**INVITATION TO BID (ITB)**

**Contract #: O-1223**

**Construction Services for Control System and DMS Fiber Communications Upgrades**

## **ADDENDUM NO. 1**

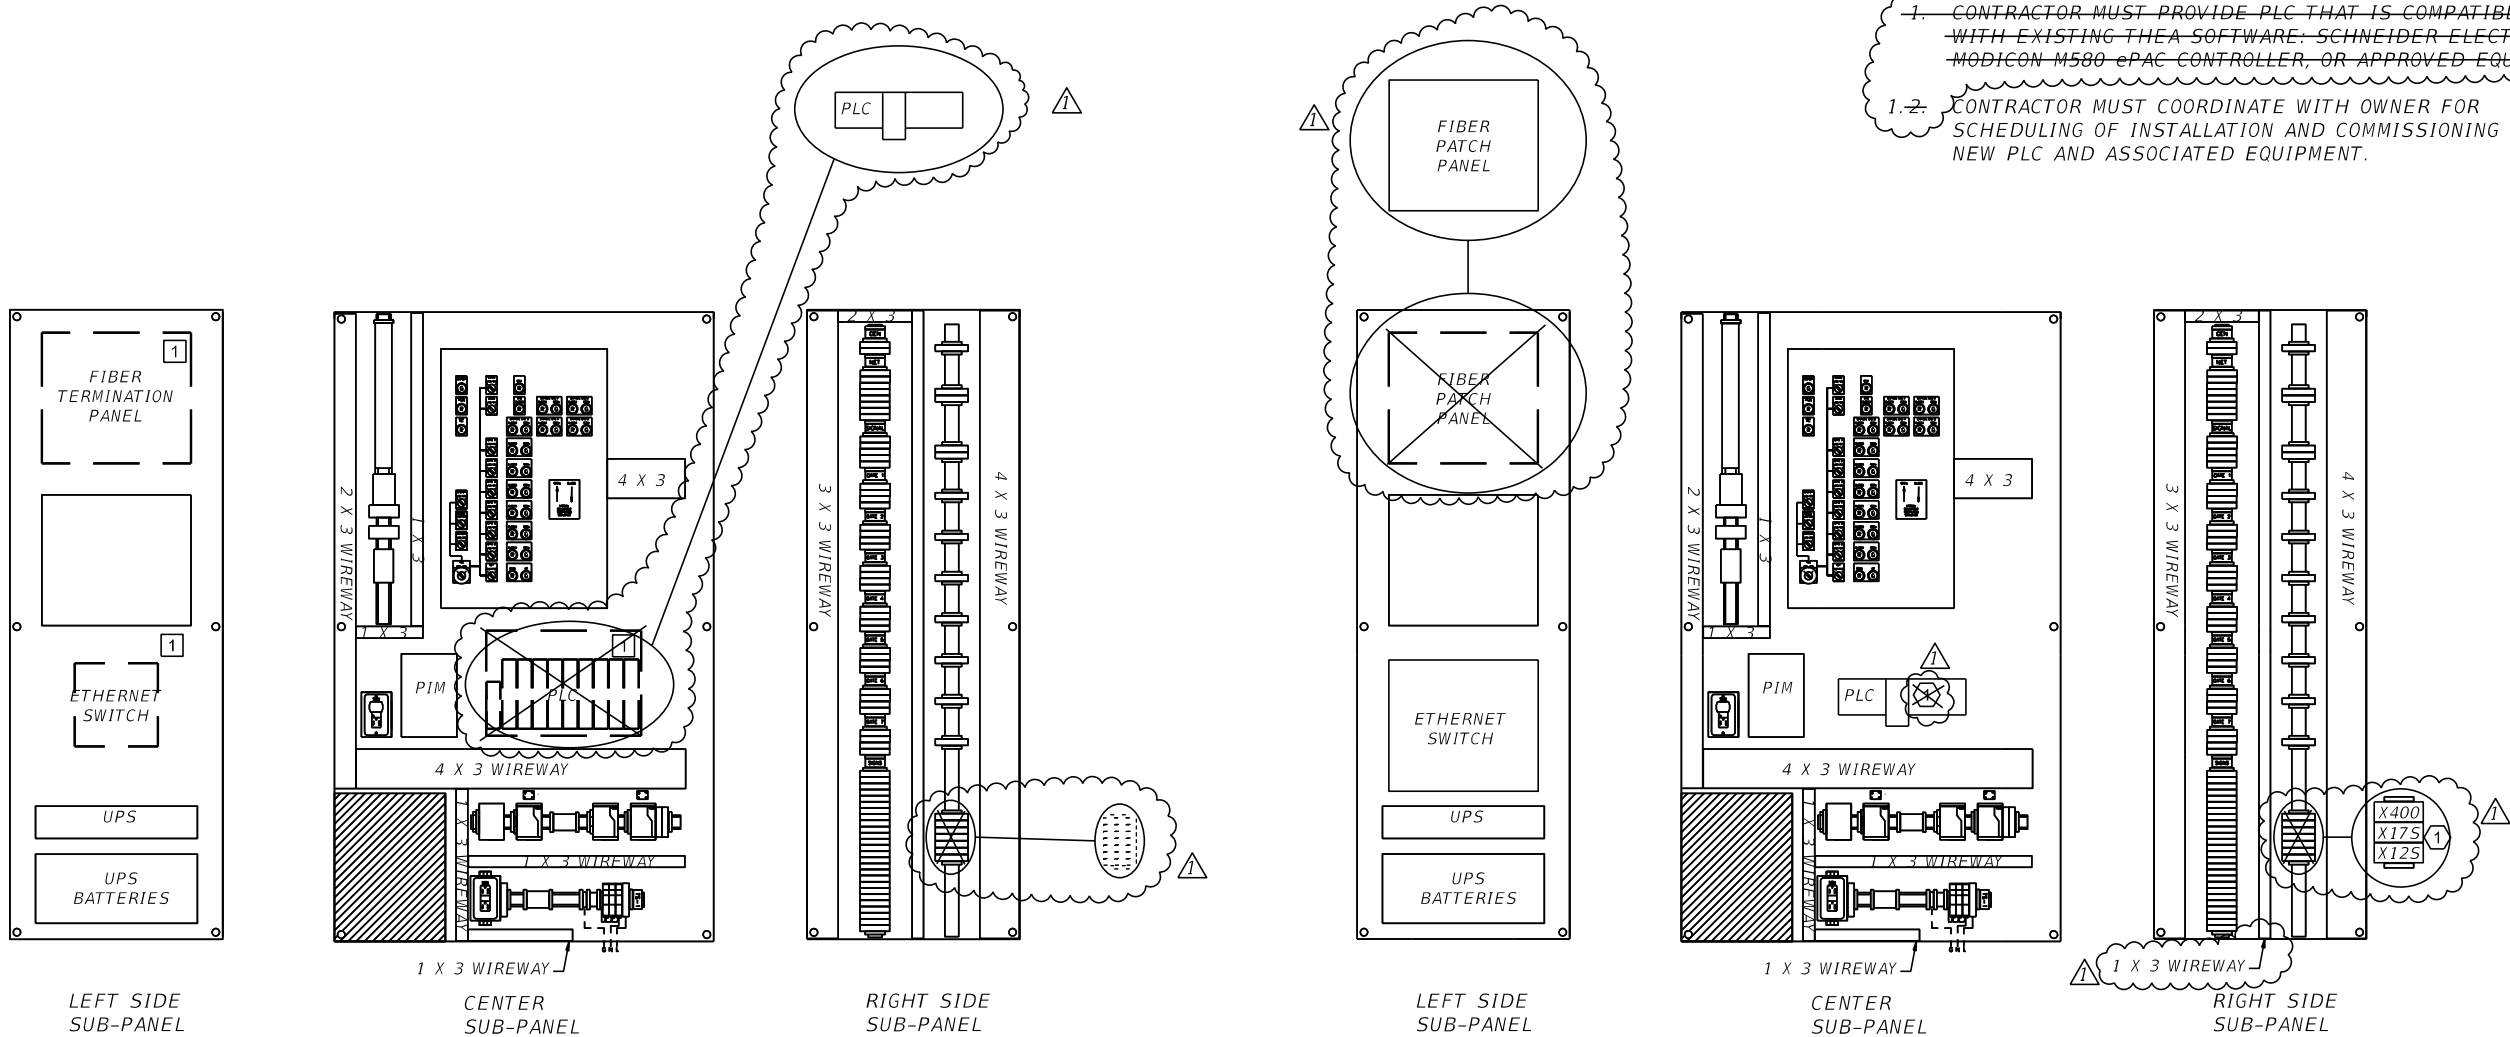
1. QUANTITY AND LAYOUTS OF EXISTING CABINETS MAY VARY.
2. SEE MTR FOR SPARE PARTS REQUIREMENTS.
3. ~~PLC SOFTWARE MUST HAVE 1 USER LICENSE TO THEA.~~
4. ~~CONTRACTOR MUST PROVIDE ELECTRONIC COPIES OF ALL SOFTWARE PROGRAM FILES, INCLUDING NATIVE PLC PROGRAMMING AND/OR CONFIGURATION.~~
